SERVICE BULLETIN

N° 139-641

ATA 25 - COLLECTIVE EMERGENCY LIFE-RAFT NEW HANDLE COVER

AEREO SEKUR SB-139-25-004

Figure 1 – Area to be bonded

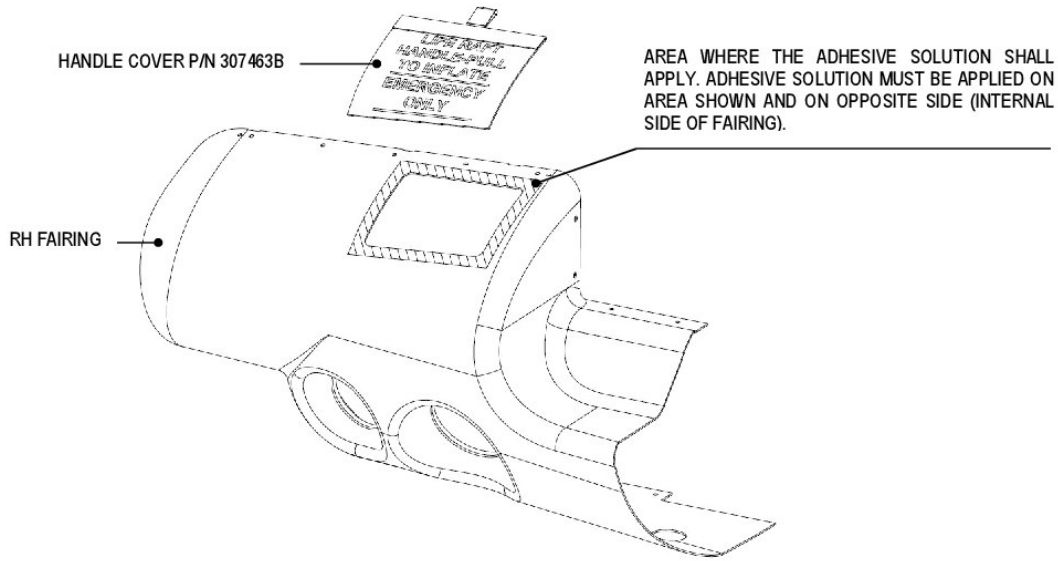
NOTE: It may be necessary to work pusher blade soaked with MEK solvent under edge of Handle Cover attachment to loosen edges.
- (2) Prepare the bonding area of Fairing and new Handle Cover P/N 307463B, ref to figure 1.
 - (a) Rub the bonding area of Fairing and Handle Cover, with a lint free cloth soaked by MEK solvent and allow to evaporate in air, for at least 30 minutes.

- (3) Apply three coats of polyurethane adhesive to each of the mating surfaces (Fairing and Handle cover), see figure 1.

Figure 2 – New Handle Cover applied on fairing

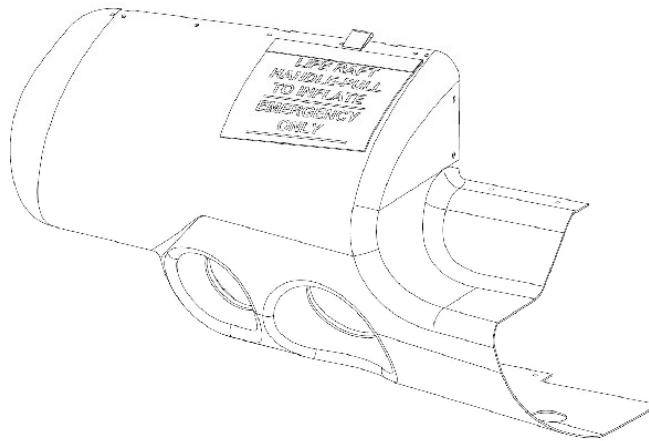
- (4) Place the new handle Cover P/N 307463B to the fairing and joint gradually, ref. to figure 2. Fold back the four textile winglets of the Handle Cover to bond them to the internal side of the fairing, ref. to figure 3.

Figure 3 – New Handle Cover applied on fairing (internal side view)

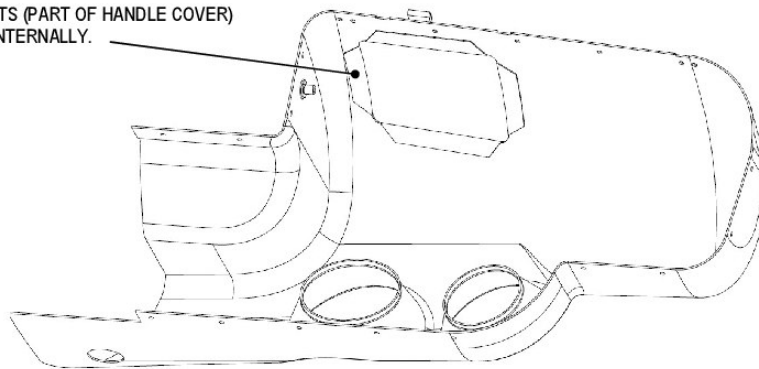
- (5) Let adhesive to cure for at least 24 Hours prior to try opening the Handle Cover.
- (6) Modify the part number of Double Head Light Fairing (Part is identified internally, ref. to figure 3). Use a permanent marker (ref. to paragraph 2.A) to cross the current part number 202811A (for right instl) or 202812A (for left instl) and add new part number 202811B (for right instl) or 202812B (for left instl).
 - (a) If present, change also the part number of Double Head Light Fairing Assy. Use a permanent marker (ref. to paragraph 2.A) to cross the current part number 202688A (for right instl) or 202689A (for left instl); then, add new part number 202688B (for right instl) or 202689B (for left instl).

- (1) Record compliance with this Service Bulletin in the component Log Card.
- (2) Record compliance with this Service Bulletin to the internal side of the Double Head Light Fairing Assy P/N 202688A or P/N 202689A (ref. to Figure 3). Use a permanent marker (ref. to paragraph 2.A) to mark the bulletin reference number (SB-139-25-004) close to the identification data modified as per step (6) of paragraph 3.A.

TEXTILE WINGLETS (PART OF HANDLE COVER)
TO BE BONDED INTERNALLY.
